**ADDENDUM 02 TO PLANS AND
CONTRACT DOCUMENTS
FOR
SHELL ISLAND WEST NRDA RESTORATION PROJECT
(BA-111)**

PLAQUEMINES PARISH, LOUISIANA

**LOUISIANA COASTAL PROTECTION
AND RESTORATION AUTHORITY**

MAY 5, 2015

GENERAL NOTES	
STATE PROJECT NUMBER: BA-11	DATE: 02/20/15
FEDERAL PROJECT NUMBER:	APPROVED BY: GT
DRAWN BY: GK

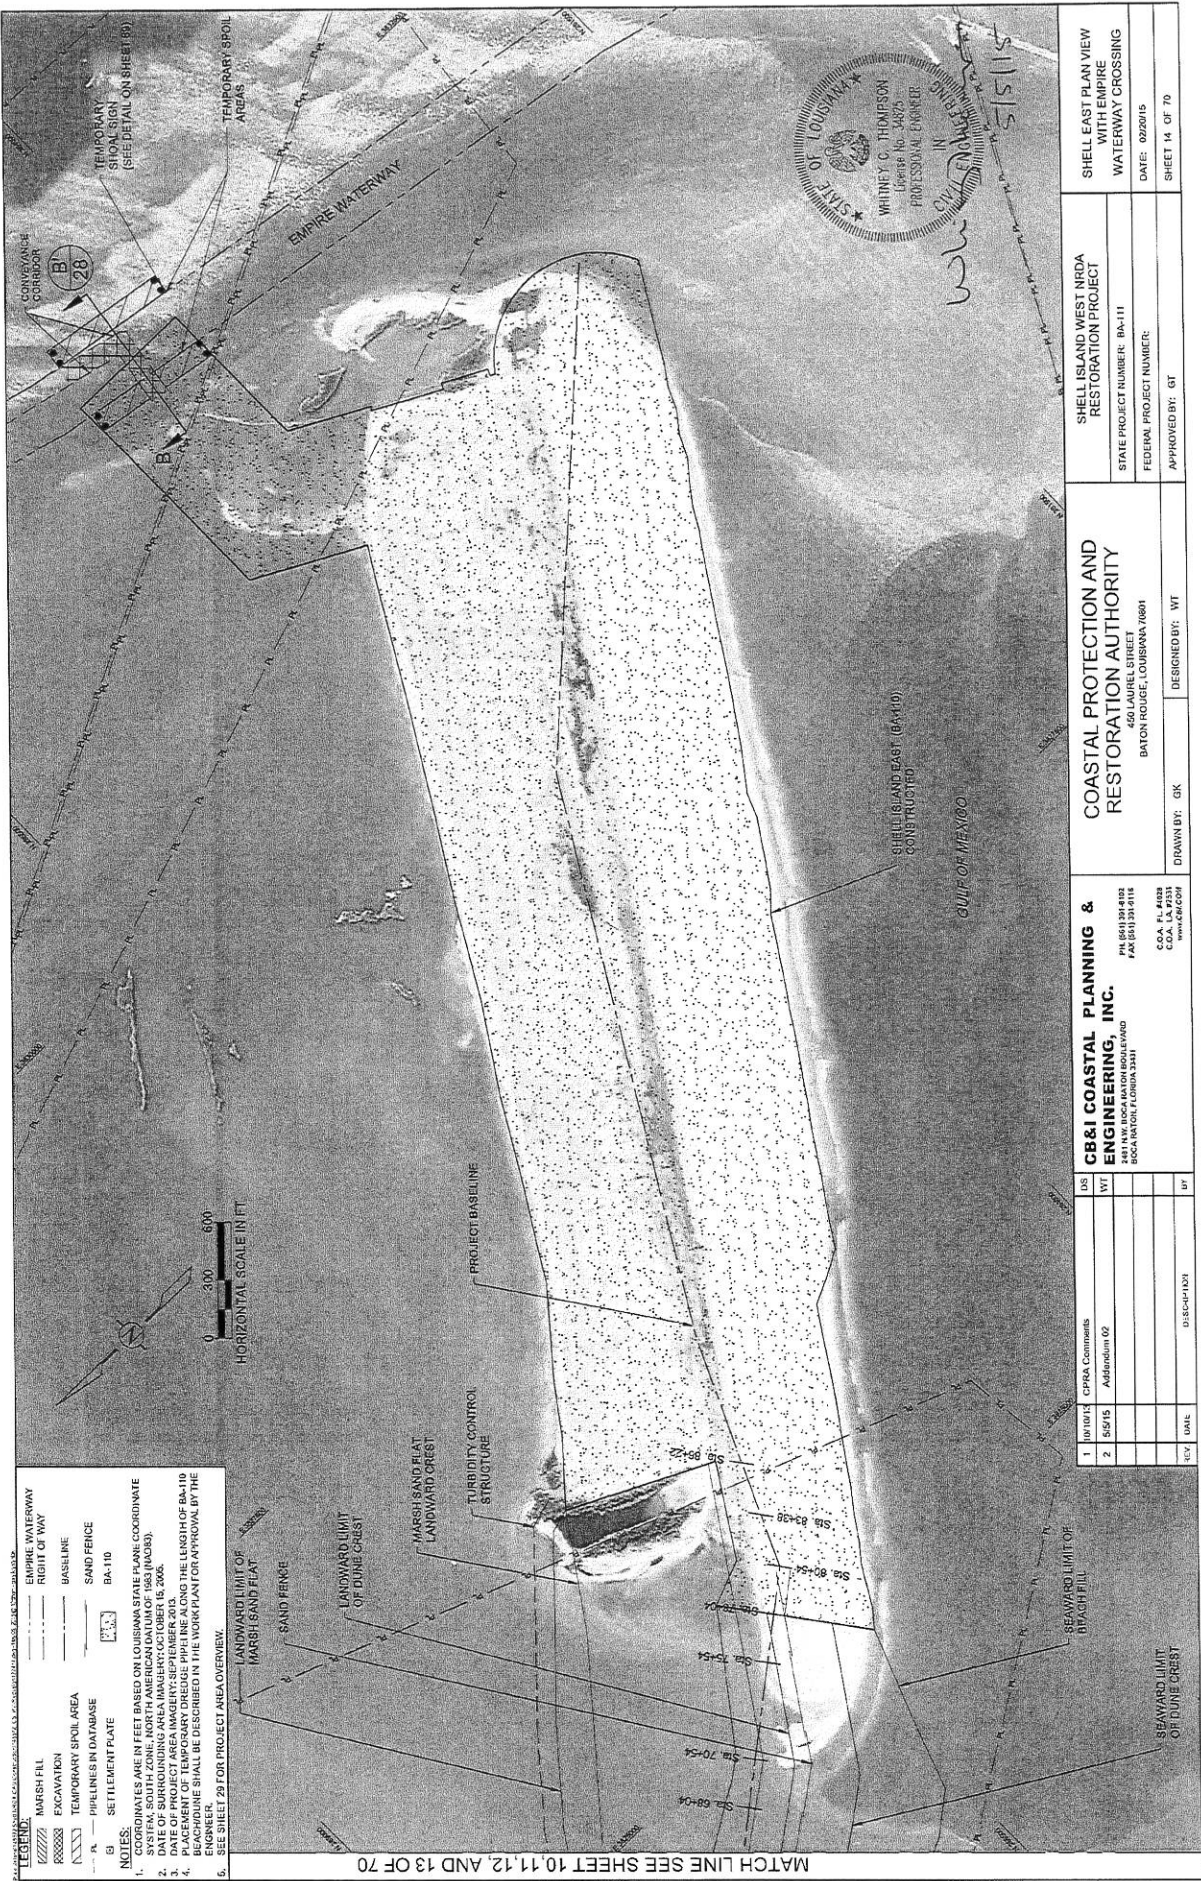
- 1.8 Question: Please add a mobilization item for Alternate 3 marsh fill to cover laying the line to the alternate 3 marsh fill area.
- Response: **Plan sheet 2 has been revised to reflect an additional mobilization and demobilization item for Additive Alternate 3. The Unit Price Form has been revised to reflect this change as well as TS-1 of the construction specifications.**

- Sheet 1: No change.
Sheet 2: Bid Item 22 Mobilization and Demobilization added and bid items renumbered.
Sheet 3: No change.
Sheet 4: No change.
Sheet 5: No change.
Sheet 6: No change.
Sheet 7: No change.
Sheet 8: No change.
Sheet 9: No change.
Sheet 10: No change.
Sheet 11: No change.
Sheet 12: No change.
Sheet 13: No change.

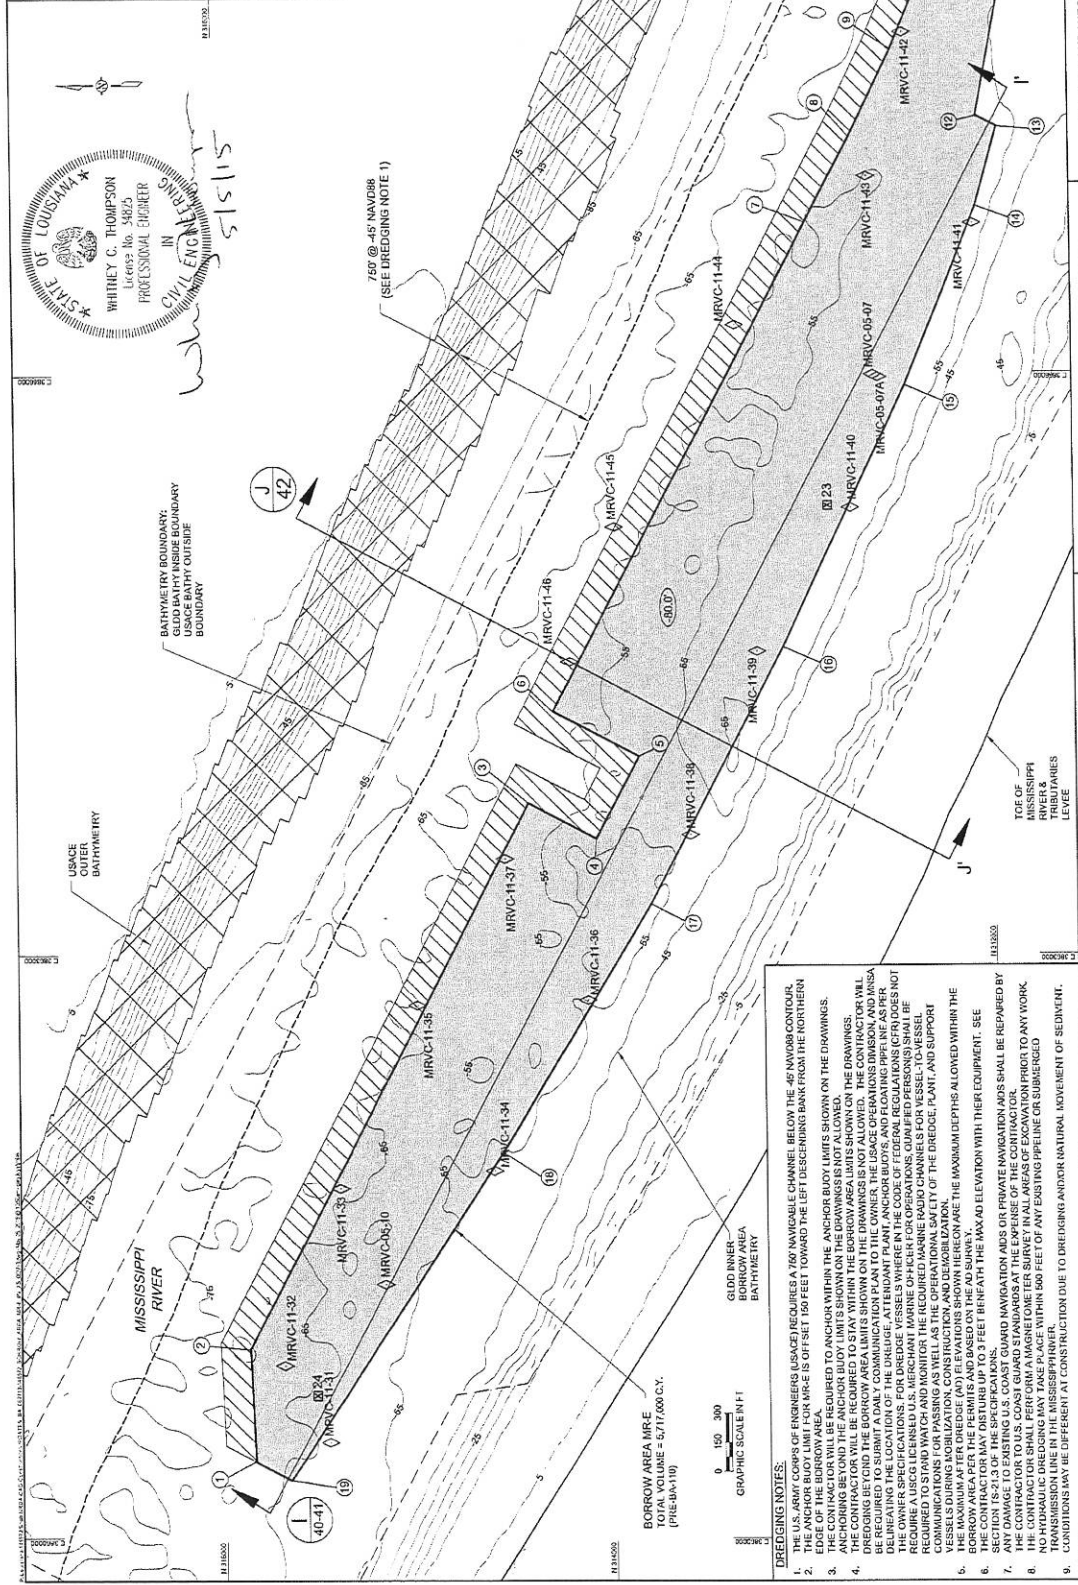
Sheet 35: No change.
Sheet 36: No change.
Sheet 37: No change.
Sheet 38: No change.
Sheet 39: Revised MR-E boundary.
Sheet 40: Revised MR-E cross section per revised boundary.

BORROW AREA MRE CROSS SECTION #1 (2 OF 2)

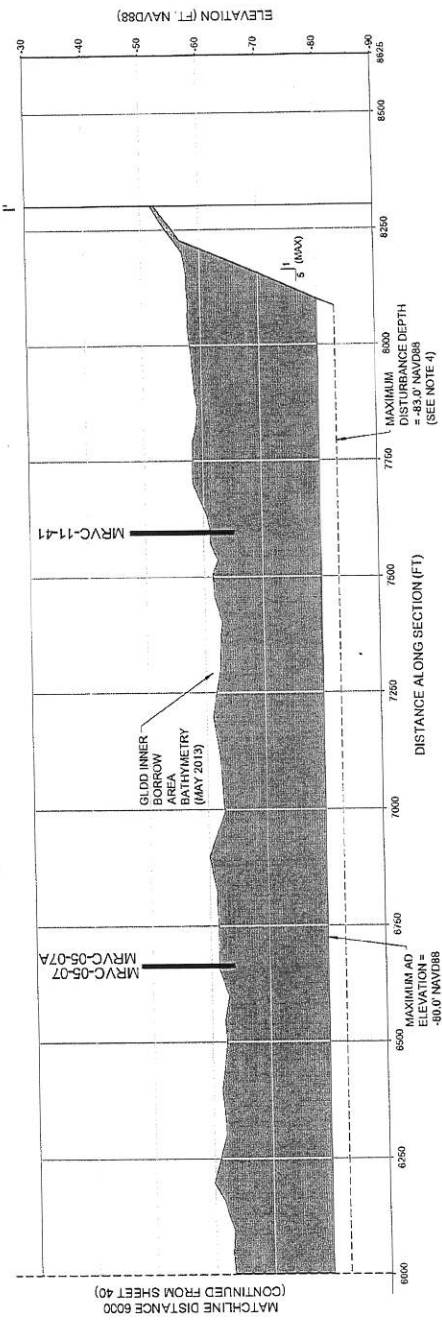
Sheet 41: Revised MR-E cross section per revised boundary.
Sheet 42: Revised MR-E cross section per revised boundary.
Sheet 43: No change.
Sheet 44: No change.

EMPIRE WATERWAY CONVEYANCE CORRIDOR LAYOUT

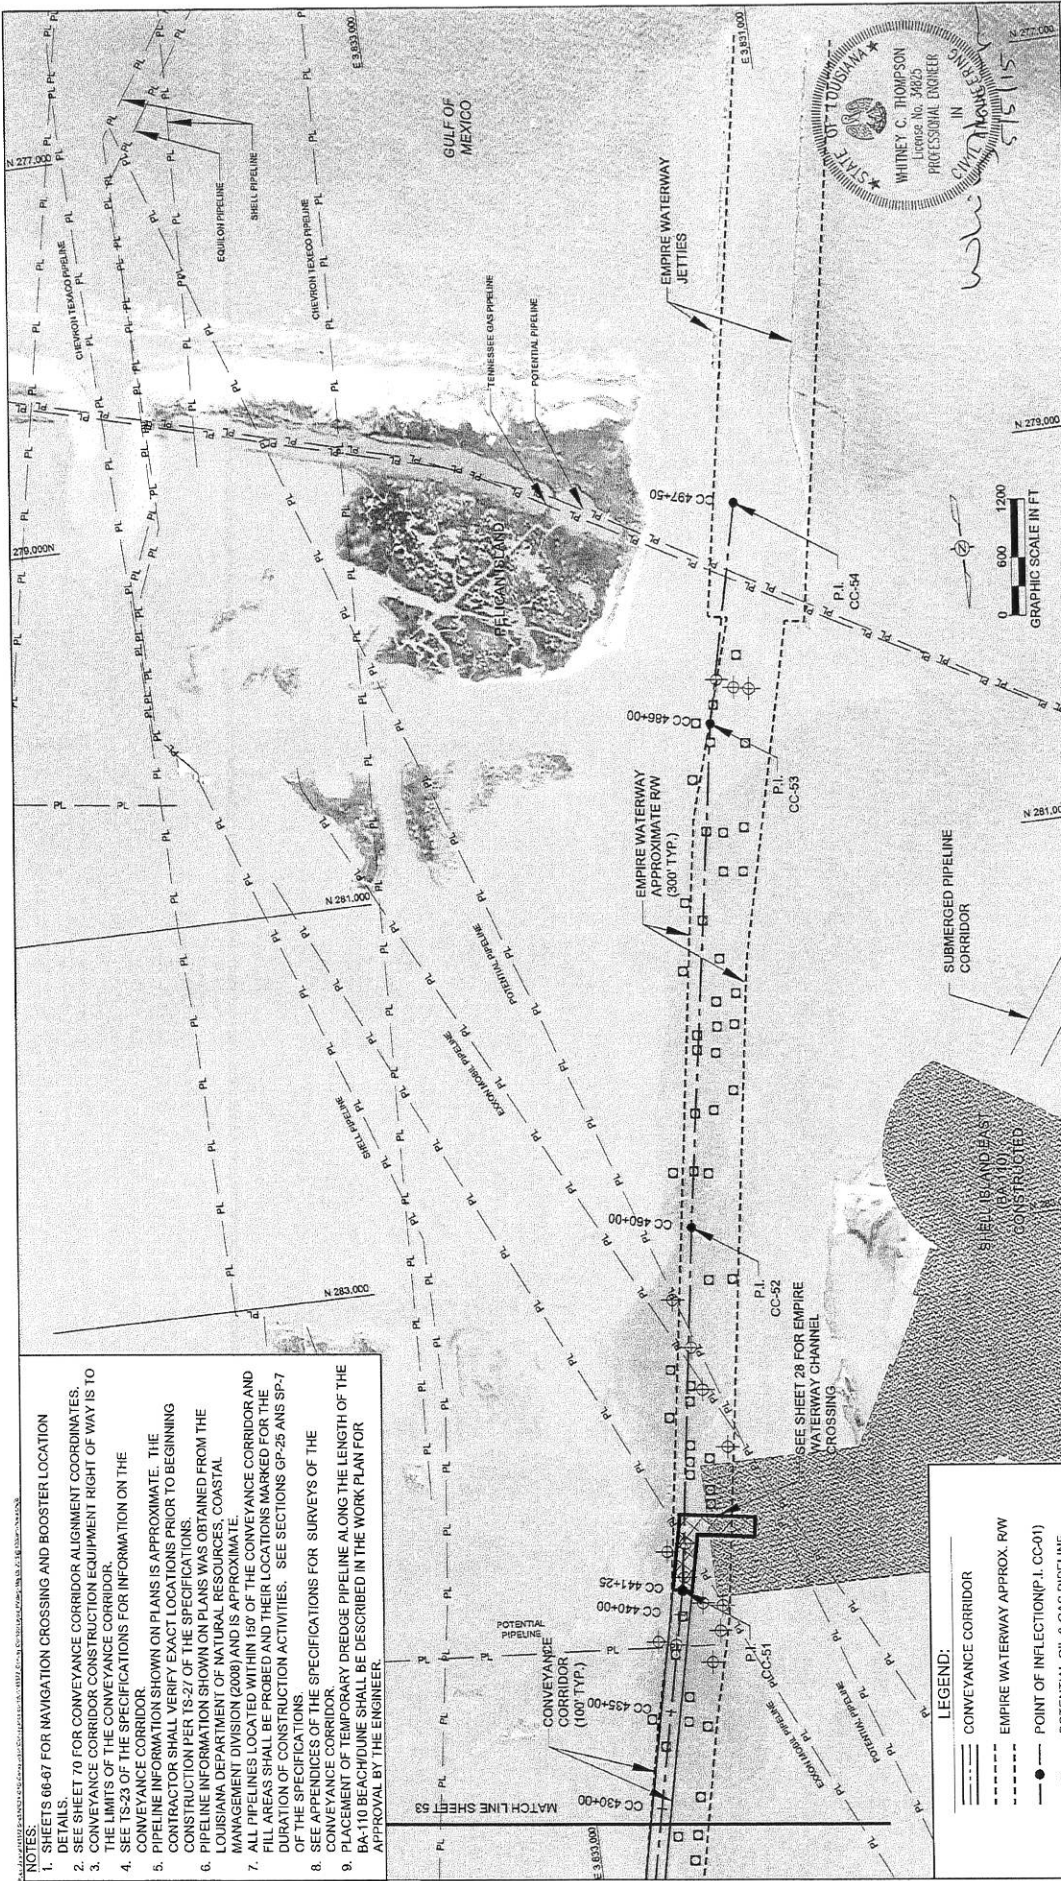
Sheet 52: No change.
Sheet 53: No change.
Sheet 54: Alternate Empire Waterway crossing removed.
Sheet 55: No change.
Sheet 56: No change.
Sheet 57: No change.
